Application by Highways England**M25 Junction 10 / A3 Wisley Interchange Improvement project****The Examining Authority's second written questions and requests for information (ExQ2)****Issued on 18 February 2020**

Question to:		Question:	
3.	Air quality and human health		Surrey County Council response
2.3.6	Applicant and Local Authorities	<p>Have the air quality implications of the Proposed Development for Ripley been robustly assessed within the ES, having particular regard to the number and suitability of receptor properties that have been used [paragraphs 5.3 and 5.4 of REP1/041] and the extent to which the Applicant's modelling has been verified and modified against the monitoring data that is available for Ripley?</p> <p>With regard to the statement in REP2-022 that the largest change was assessed to occur at Receptor 6 but was classed as 'small', please explain the significance of this change in EIA terms and whether it affects the conclusions of the ES.</p>	This is not a matter on which SCC can comment. Air quality monitoring and management is a District and Borough responsibility and therefore GBC and EBC are the planning authorities with access to the relevant expertise

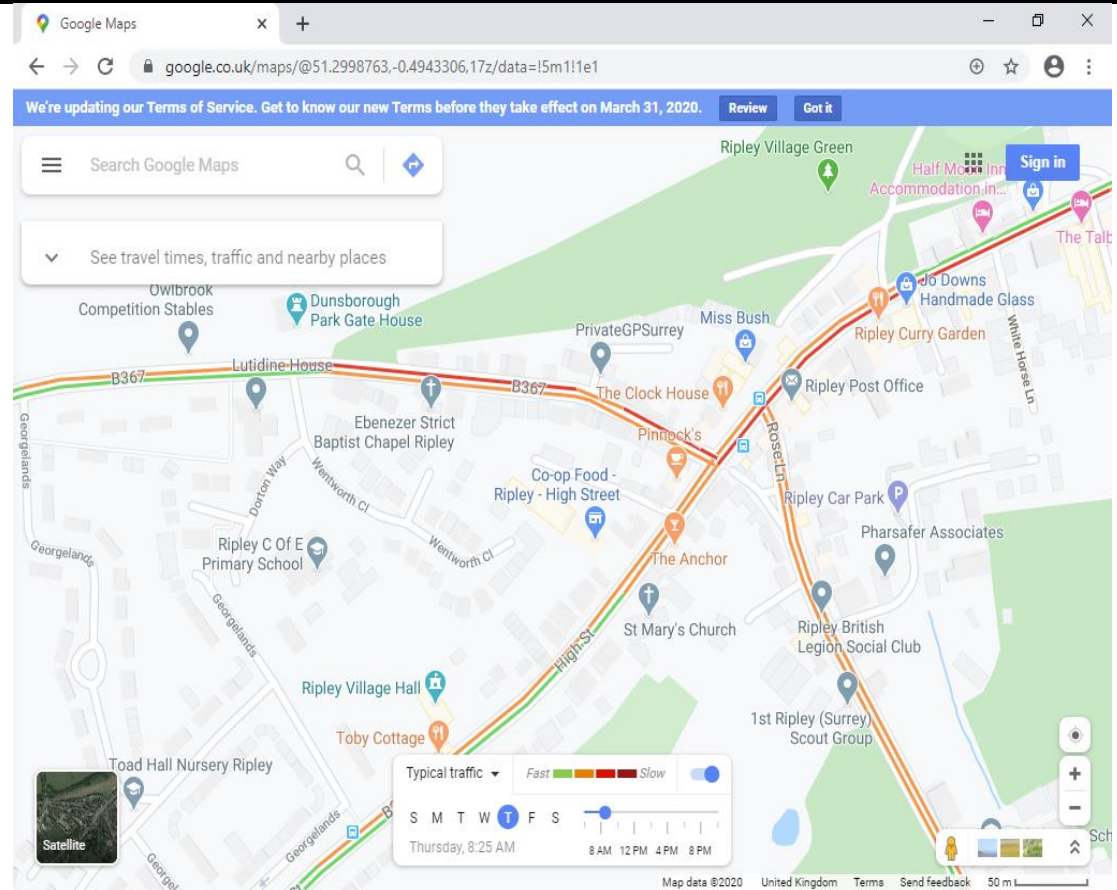
2.13.11	Applicant, SCC and RHS	<p>Notwithstanding that SCC would not wish to promote the use of a vehicular route from RHS Wisley via Wisley Airfield and Old Lane onto the A3, as stated at Issue Specific Hearing 2 and in REP3-036, given that allocation A35 of the Guildford Local Plan 2019 requires a through route to be available between the Ockham Park junction and Old Lane, what proportion of the southbound vehicular traffic exiting RHS Wisley might route via the airfield as an alternative to either making a U-turning</p>	<p>SCC consider that it is likely that either only a very small proportion of southbound traffic or minimal vehicles will take this route. This is because the through route is likely to be subject to a 20mph speed limit, traffic calmed and circuitous with motorised vehicles subject to other modes (pedestrians, cyclists and buses) having priority.</p>

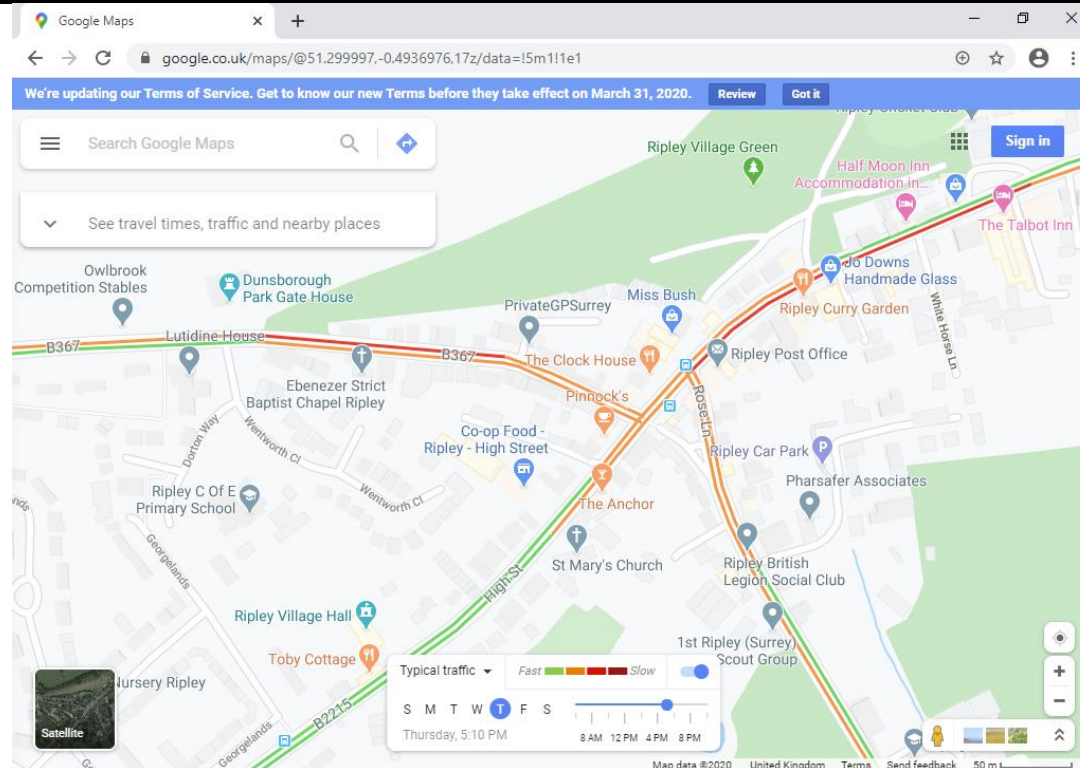
Question to:		Question:
		<p>a) Confirmation as to whether the base year (2015) traffic flows identified by the Applicant in the submitted application documentation for the B2215 (Portsmouth Road/Ripley High Street), Newark Lane and Rose Lane are or are not agreed.</p> <p>b) Assuming the Proposed Development were to be consented and implemented, confirmation as to whether the predicted AM peak, Inter-peak and PM peak hour traffic flows for the Do-minimum and Do-something scenarios in 2022 and 2037 identified by the Applicant in the submitted application documentation are or are not agreed.</p>
		<p>assist in SCC taking a view. SCC agree that the calibration and validation of the model is satisfactory for the purpose of the model in the context of NSIP scheme.</p> <p>b) The Do-minimum and Proposed Development predicted 2022 and 2037 AM peak, Inter-peak and PM peak traffic flows are not agreed by SCC. This is because of the uncertainty in traffic flows modelled as set out in paragraphs 7.2.1.12 to 7.2.1.18 of the Joint Council Local Impact Report (REP2-047), uncertainty in how growth has been applied in the model and the lack of a mitigation scheme for Ripley as set out in paragraph 7.2.1.20 of REP2-047. SCC and the Applicant are working on clarifications to seek agreement on these matters.</p> <p>c) SCC considers that the links are currently operating within theoretical capacity along B2215 between A3 and A247. However, this is not the only criteria that should be applied to B2215 especially where the road passes through Ripley. The current traffic flows have a significant impact on the place making and severance that occurs within Ripley High Street and the environmental and social impact is more applicable than applying theoretical capacity of a link. SCC considers that the B2215's junction with Newark Lane currently operates at capacity particularly during peak periods. Significant queuing and delays currently occur on Newark Lane and along B2215. This is shown in the attached Google extracts for AM Peak and PM peak periods.</p>

- c) Confirmation as to whether any of the B2215's links between its junctions with the A3 and A247 and the B2215's junctions with Newark Lane and Rose Lane are or are not currently operating at capacity.
- d) For any link or junction referred to in c) above for which it is predicted that the capacity will be exceeded in the future (ie post-dating the operation of the Proposed Development should it receive consent), please provide an indication when it is expected the capacity of the link or junction would be exceeded and what the reason for the capacity

exceedance would be.

You are reminded in addressing the above listed matters in the SoCG that for any matter that is not agreed a full explanation for why there is disagreement shall be provided.

- d) At the Newark Lane/B2215/Rose Lane junction, Highways England predict that in 2022 with the scheme in place compared with 2015, traffic flows will increase through this junction by 25% during the AM peak and 39% during the PM peak (Table 7-9 of APP-136 Transport Assessment Report). In 2037 with the scheme in place traffic flows are predicted to increase compared with 2015 by 58% in the AM Peak and 80% in the PM peak. They also consider that in 2022 and in 2037 with the scheme in place the junction will continue to operate within capacity (Table 7-10 of APP-136). SCC does not accept that this junction will be operating with reserve capacity in the future given the proposed increases in traffic flows. SCC considers that this junction operates at capacity in 2020. The capacity exceedance is likely to be caused by
